BOROUGH OF OCEANPORT PLANNING/ZONING BOARD

REGULAR MEETING • AGENDA

MAY 13, 2025 at 7:00 PM

LAURINO SUBDIVISION

IMPROVEMENTS PLAN

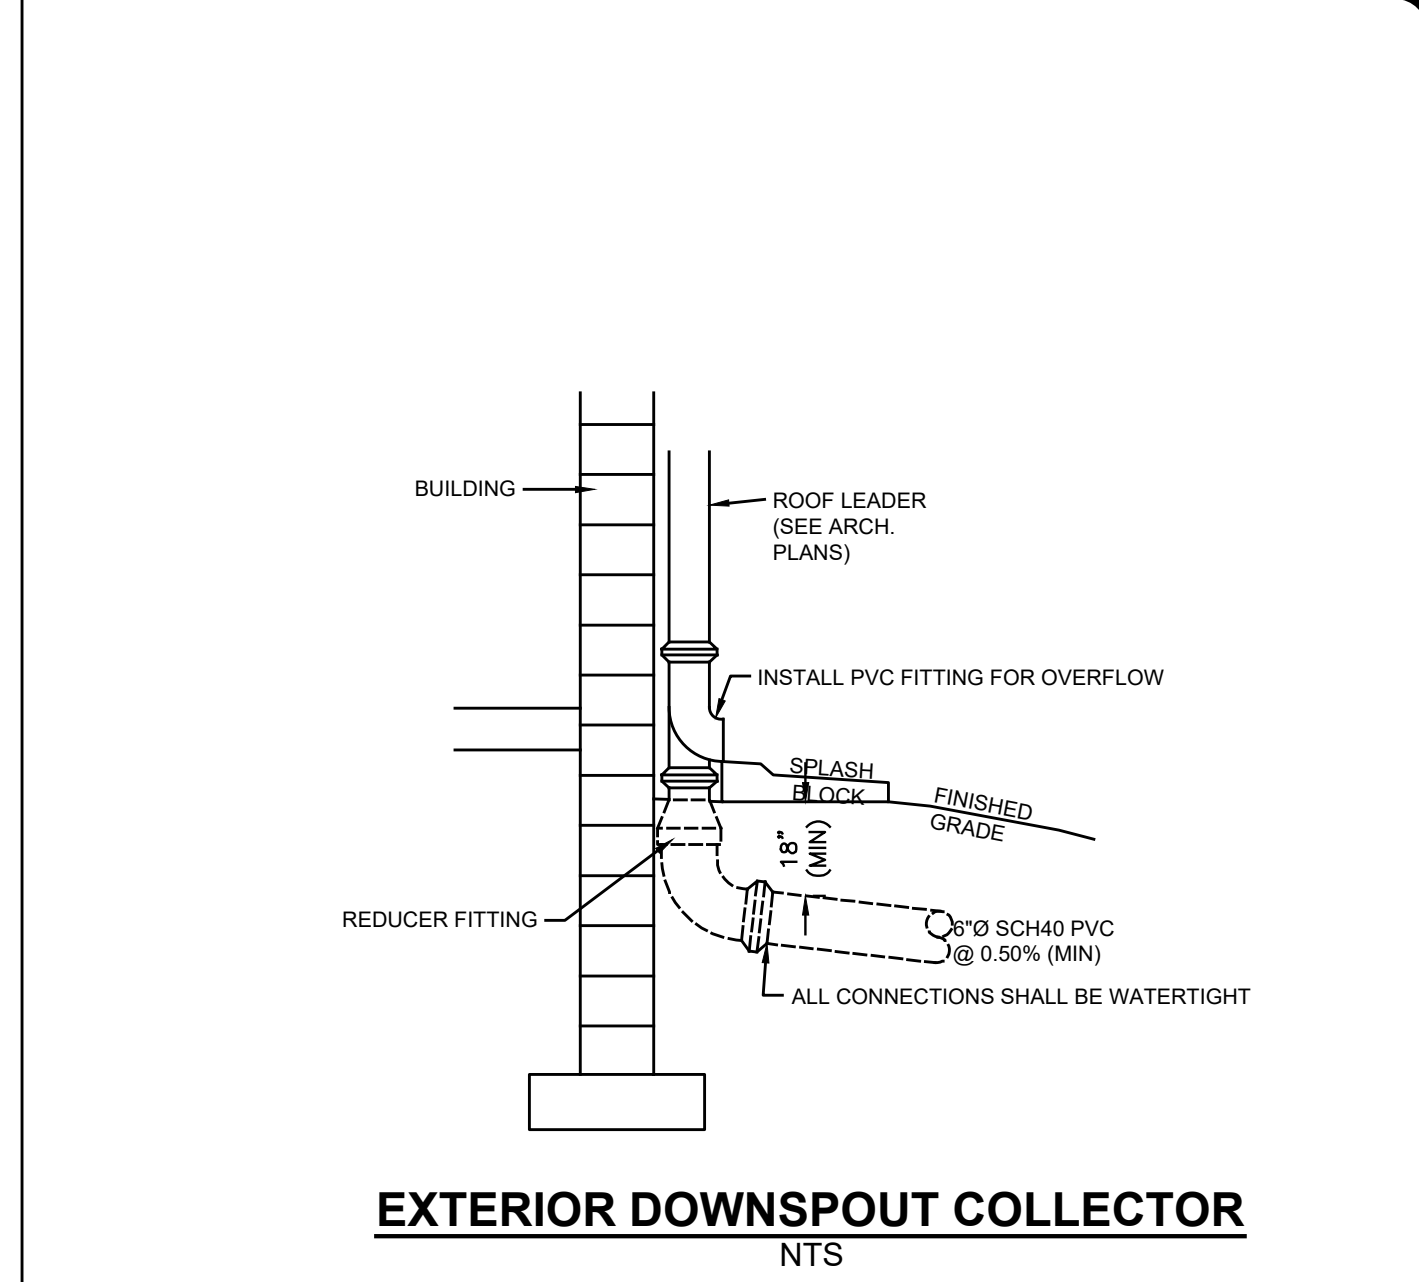
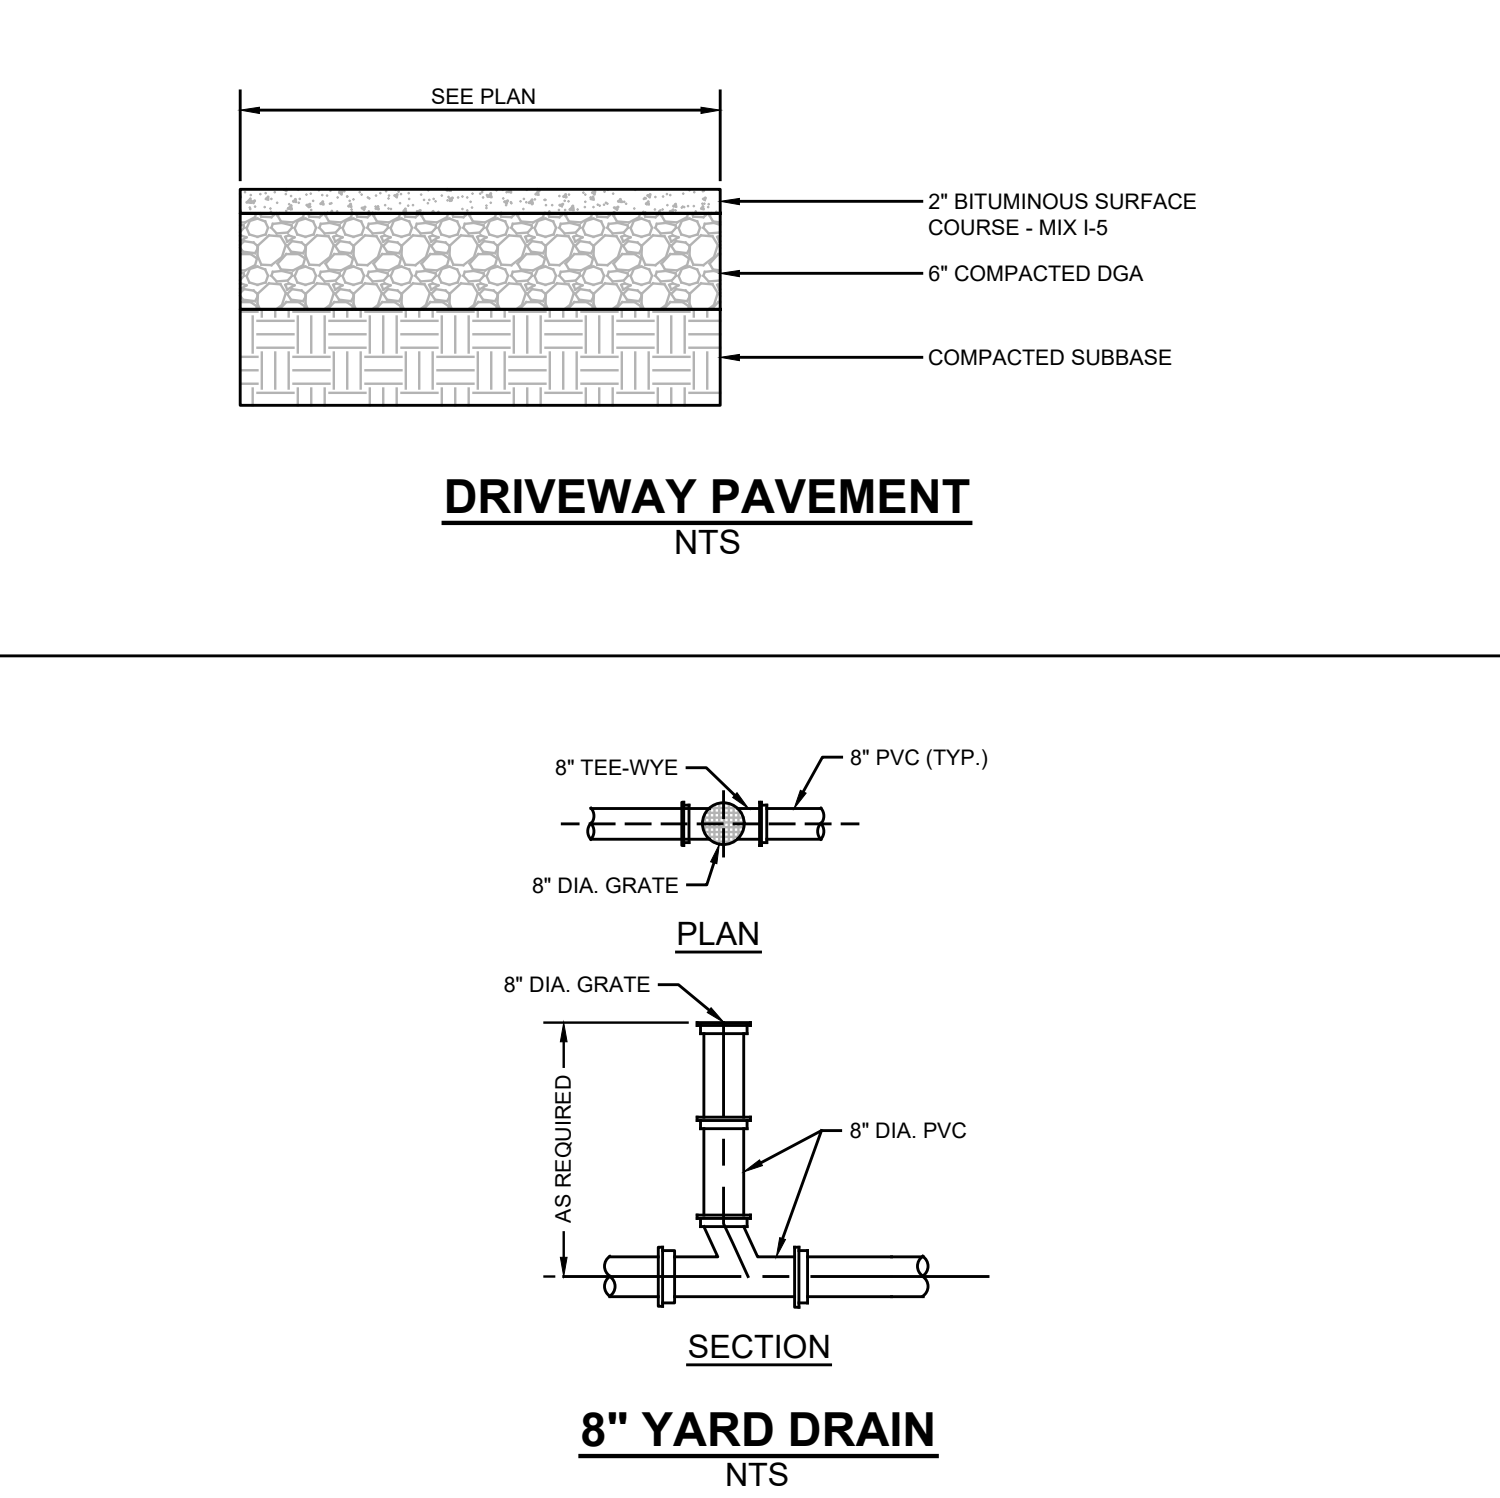
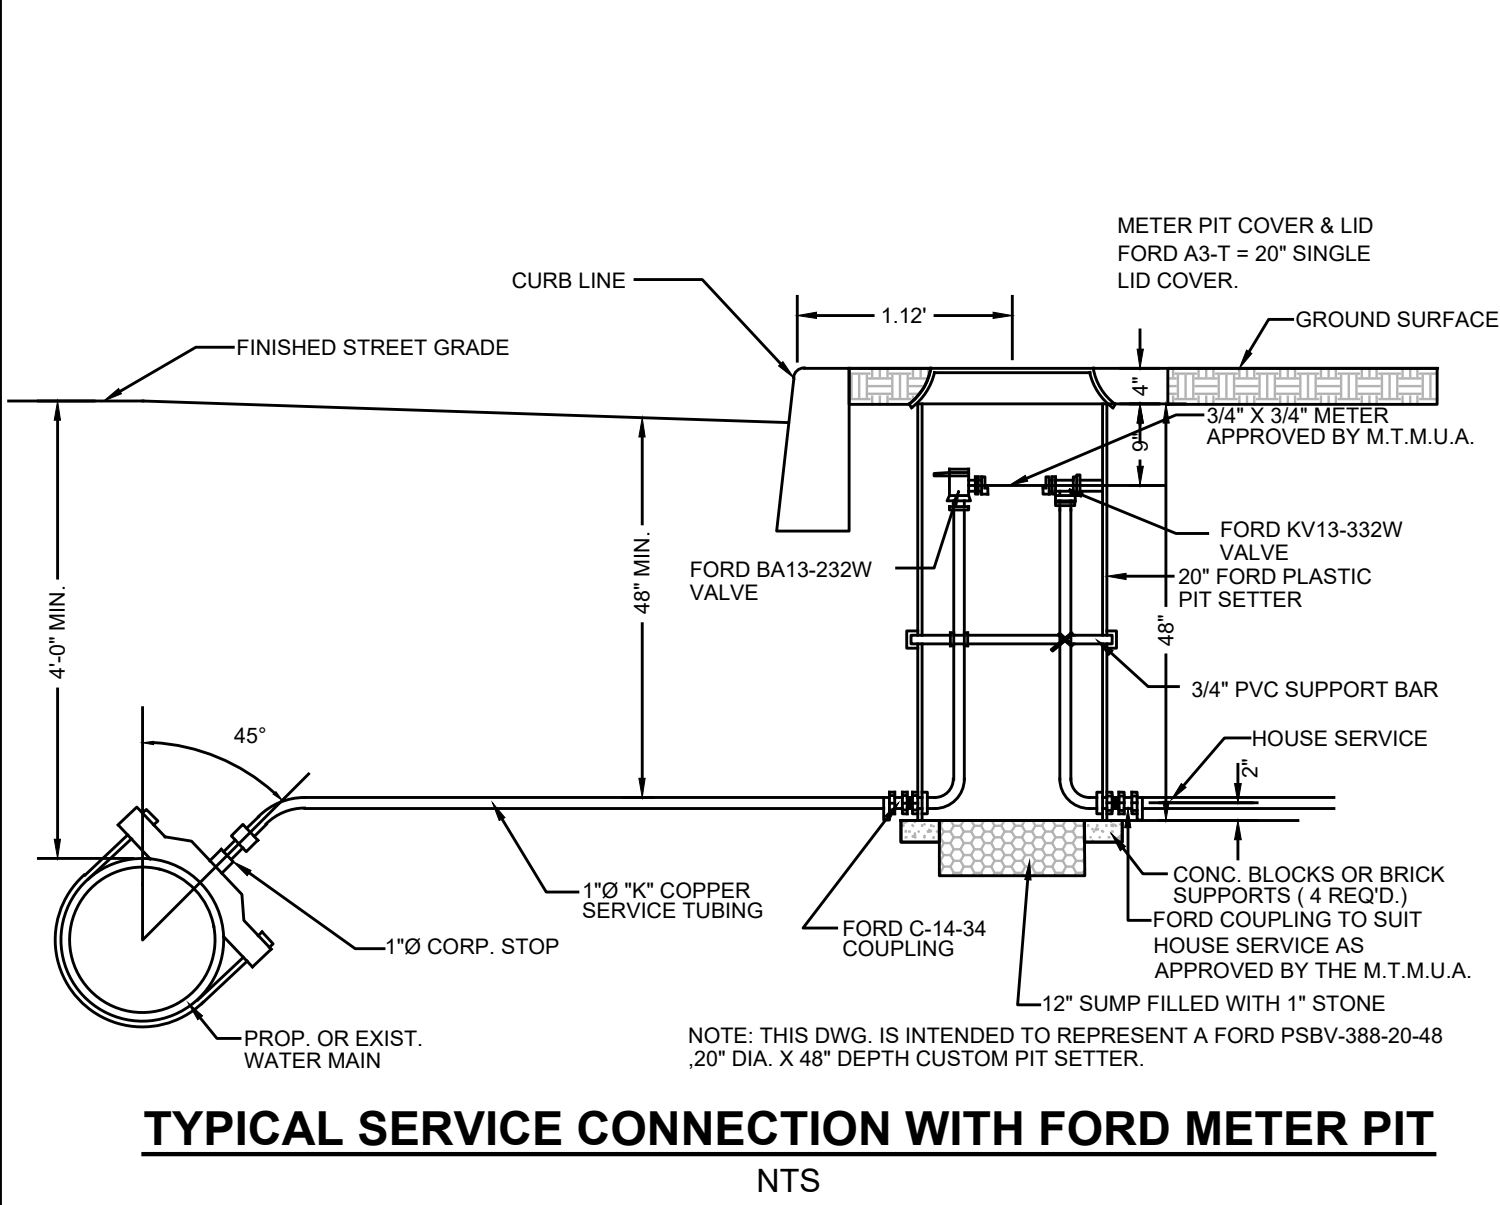
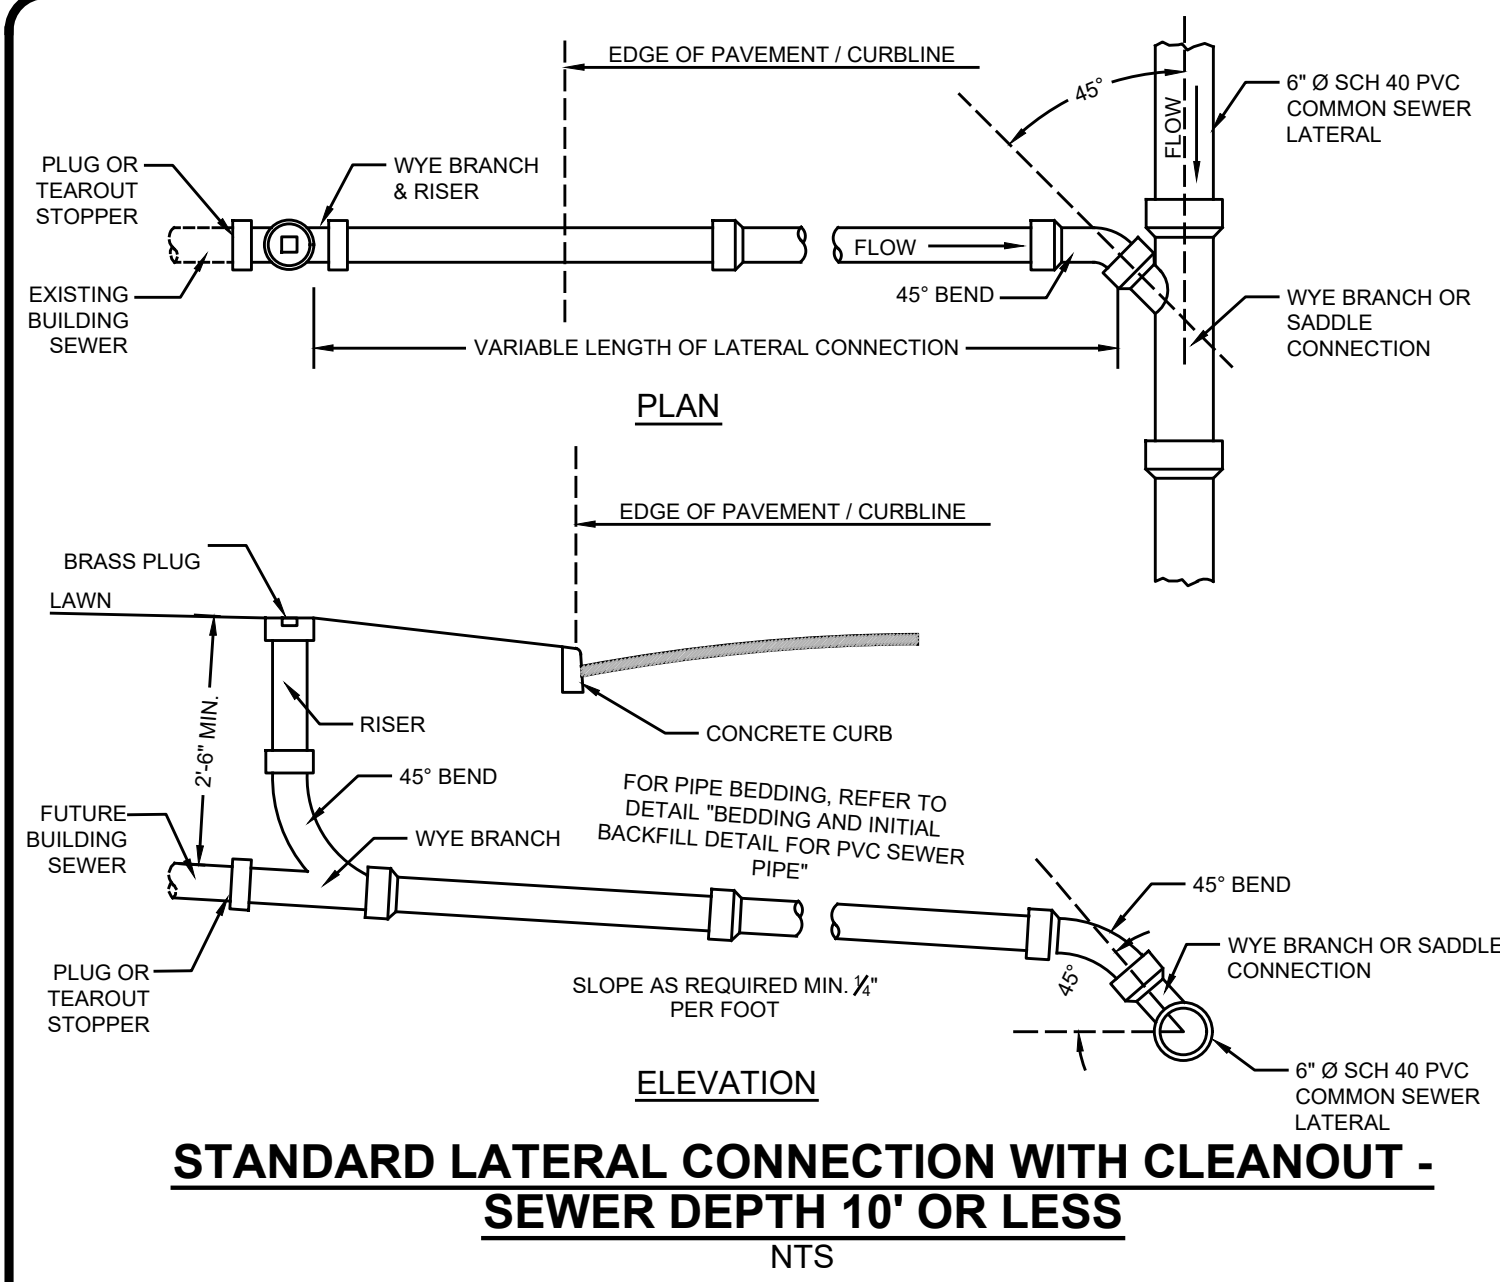
3. The Applicant shall demonstrate how the building height was measured for each dwelling.
4. The new lot numbers shall be revised so Lot A is 5.01 and Lot B is 5.02.
5. The Applicant proposes a basement on Lot A and crawlspace on Lot B. The lowest floor shall be at least 2 feet above the Seasonal High Ground Water Table (SHGWT). Test pits are required to determine the elevation of the SHGWT.
6. Tree species and size along with a planting detail is required.

CONCRETE PLAN
SCALE: 1/4" = 1'-0"

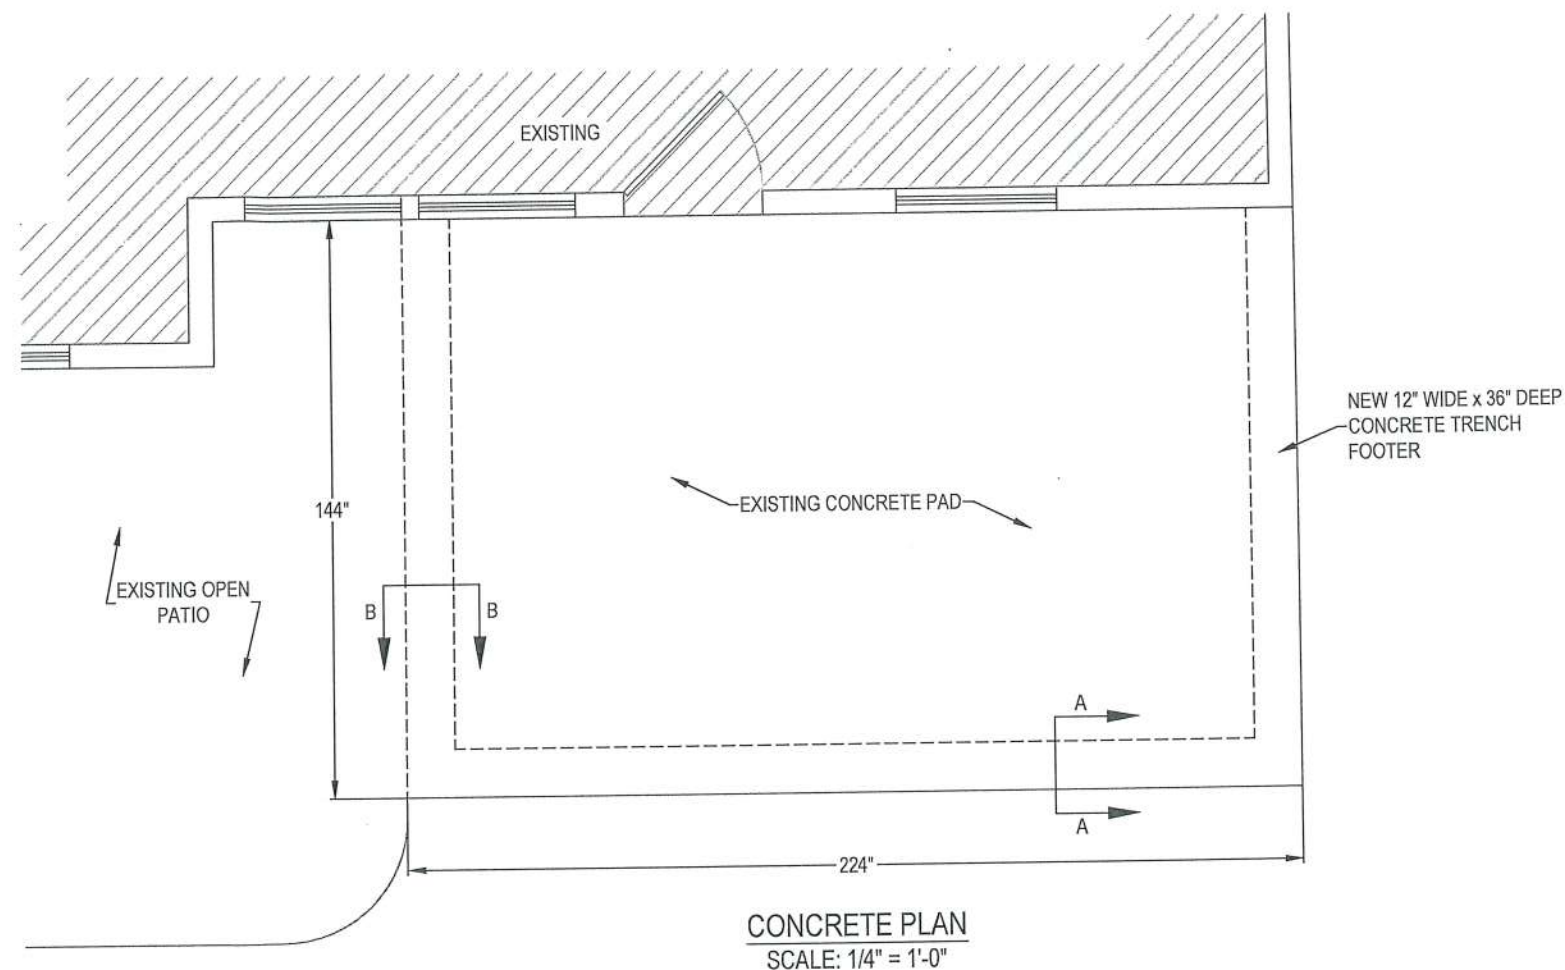
1. The Applicant shall provide computations of the Building and Impervious coverages to demonstrate compliance with the zone requirements or request the necessary variance(s);
2. If approved, a signed and sealed copy of the survey shall be provided to the Board Secretary; and,
3. The Applicant shall clarify if the remainder of the concrete patio should remain.
